Letter from C. A. Schrock (WPSC) to NRC Document Control Desk

Description of Revisions to the Kewaunee Nuclear Power Plant

Operational Quality Assurance Program Description

Revision 13

FIGURE 1  
OFFSITE FUNCTIONAL QUALITY ASSURANCE ORGANIZATION

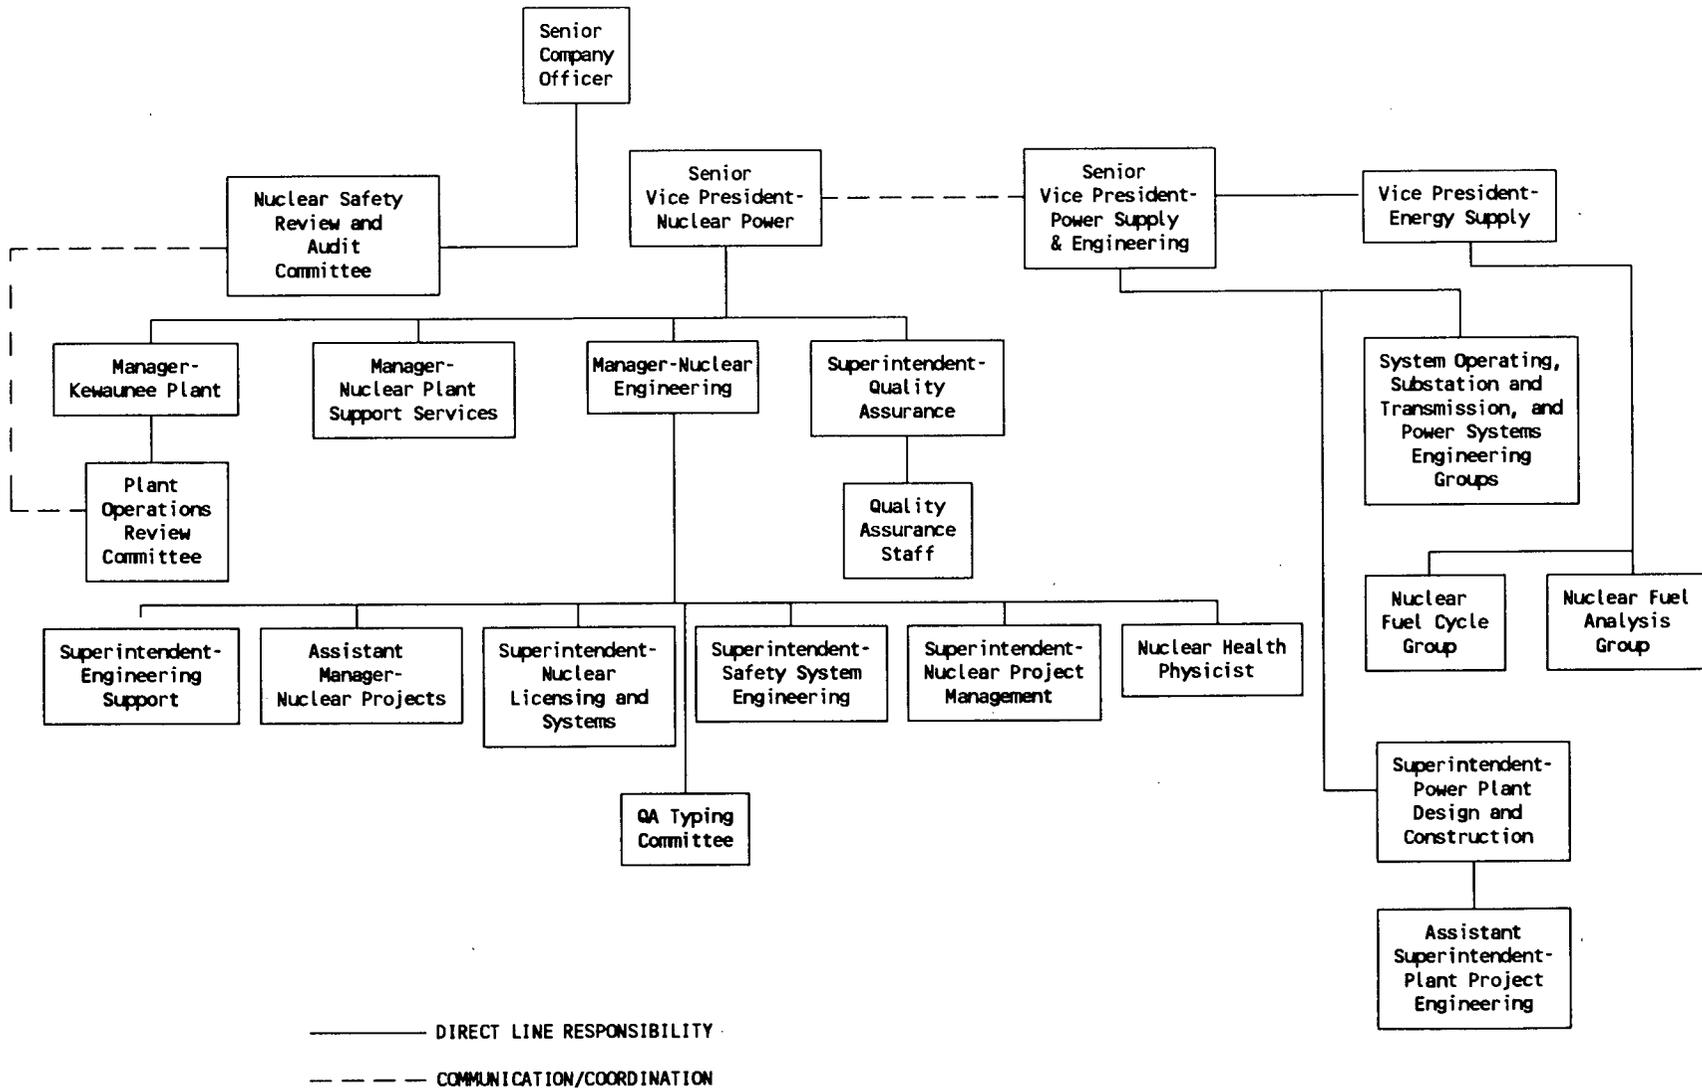
Figure 1  
Page 25

The title of Assistant Vice President - Energy Supply has been replaced by Vice President - Energy Supply. This change has been previously discussed. The figure has also been revised to show the Nuclear Fuel Cycle Group and the Nuclear Fuel Analysis Group report directly to the Vice President - Energy Supply.

This change reflects the current organizational structure of WPSC.

This change is due to an oversight in the last revision of the OQAP Description. The Nuclear Fuel Cycle Group and the Nuclear Fuel Analysis Group report directly to the Vice President - Energy Supply, who reports to the Senior Vice President - Power Supply and Engineering. This change is administrative in nature and does not change the responsibilities described in the OQAP Description.
